DEVIATION REQUEST  
AND DECISION FORM IN  
ASSOCIATION WITH A  
REQUEST FOR A PUD  
MODIFICATION FROM  
THE ECM

**WATERSIDE TOWNHOMES**  
**DEVIATION REQUEST - ECM SEC. 2.3.8.A.**  
PCD FILE NO. PUDSP-22-009

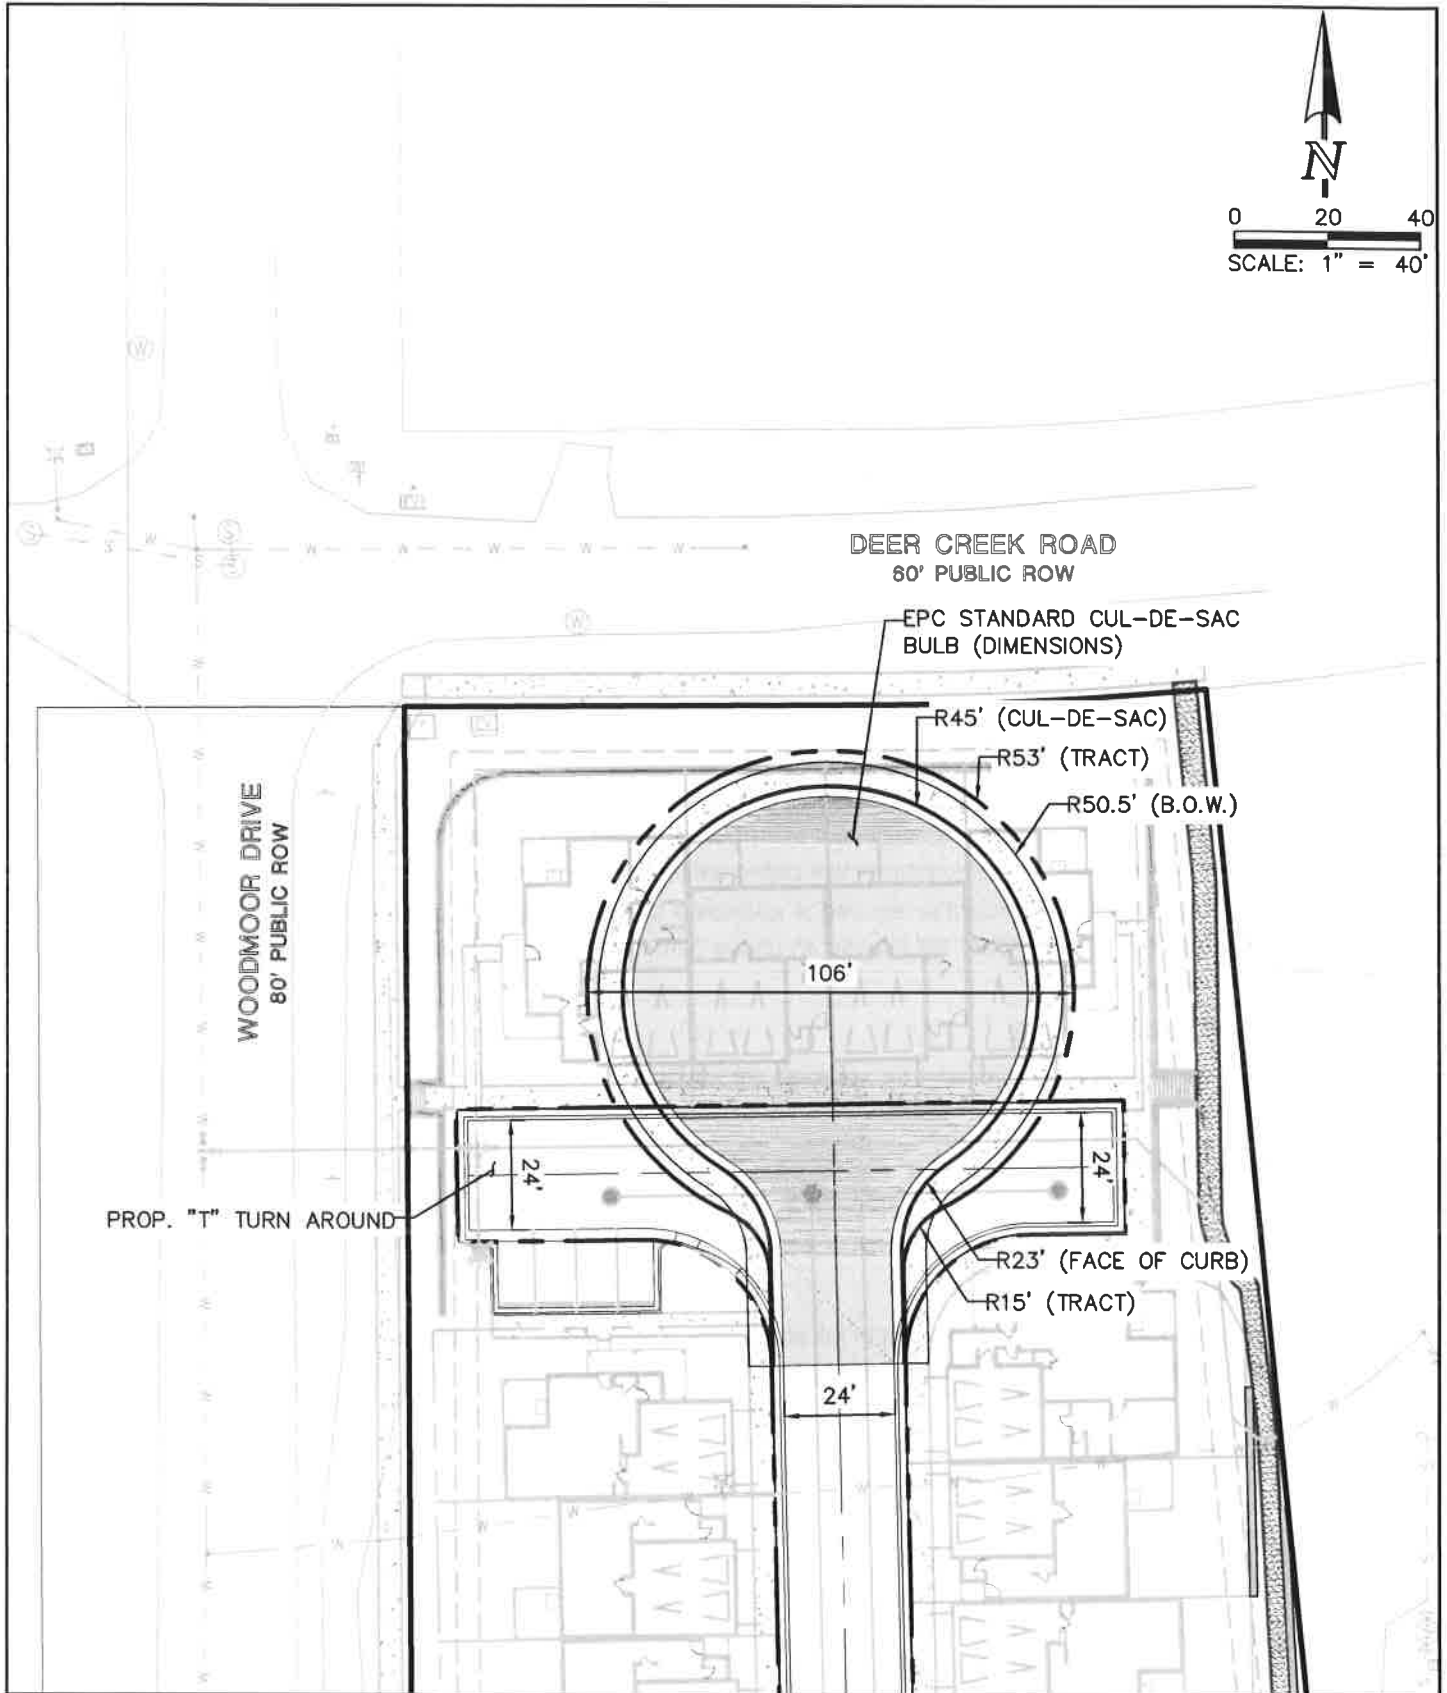
Roadway Terminations – Hammerhead turnarounds are not permitted as permanent roadway terminations.

The unique urban residential community consists of townhomes. While the main community access is from standard public local roadways, the use of the private roadways is limited to closed looped areas that will be signed as being private. A single private hammerhead is proposed for the northerly roadway terminus since access to Deer Creek Road is not allowed. Adequate emergency vehicle backing and maneuvering areas are provided.

The proposed short dead-end stubs (hammerhead turn around) allow the continuations of the community design concept with no adverse impacts to resident maneuverability. Only residents occupying the proposed four (4) townhomes will use the turnaround area to access their garages. Anyone unfamiliar with the site could utilize the private hammerhead to turnaround and exit, if needed, similar to the operational aspects of a cul-de-sac.

The northerly turn around area is proposed due to the limited access spacing along Deer Creek Road (i.e. no access), and the small amount of traffic that would be present within the proposed community. The width of parcel is only slightly larger than the width of a standard cul-de-sac bulb, severely limiting the community use of this area (see attached exhibit).

The private roadway turn around is the same width as a public country local (low volume) street section, therefore no adverse aesthetic impacts are anticipated. In addition, per the attached exhibit, a standard cul-de-sac would require a much larger asphalt field, basically filling in this section of the site with asphalt.

The Deviation is only valid until and unless the Board of County Commissioners approves the Planned Unit Development Modifications.

We have reviewed the attached hammerhead as proposed and approved the modifications.
